CTV Building

Diaphragm to Wall on grid 5
connection for E-W earthquake

11/8/12

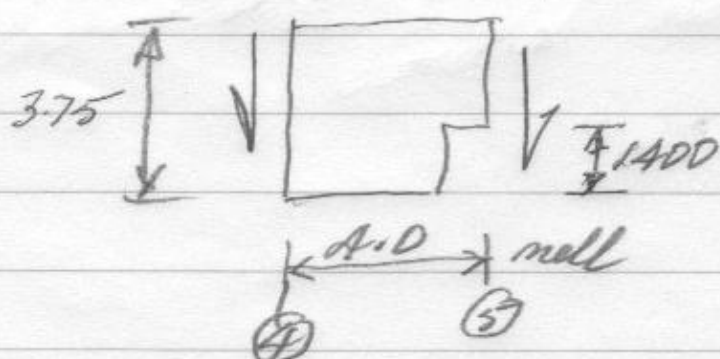
COR not defined in calculations
but approx 4.5m from COM.

$$\text{C.O.G.} - \text{C.O.R.} \approx 4.5$$

$$\text{C.O.G.} - \text{C.O.R.}_{\text{max}} = 4.5 + 2.25 = 6.75 \text{ m.}$$

∴ load share for wall on grid 5

$$= \frac{626}{2} + 626 \times \frac{6.75}{22.5} \approx 478 \text{ kN}$$

Shear to be transferred from grid 1 to 5
at level 6 $\approx 480 \text{ kN}$
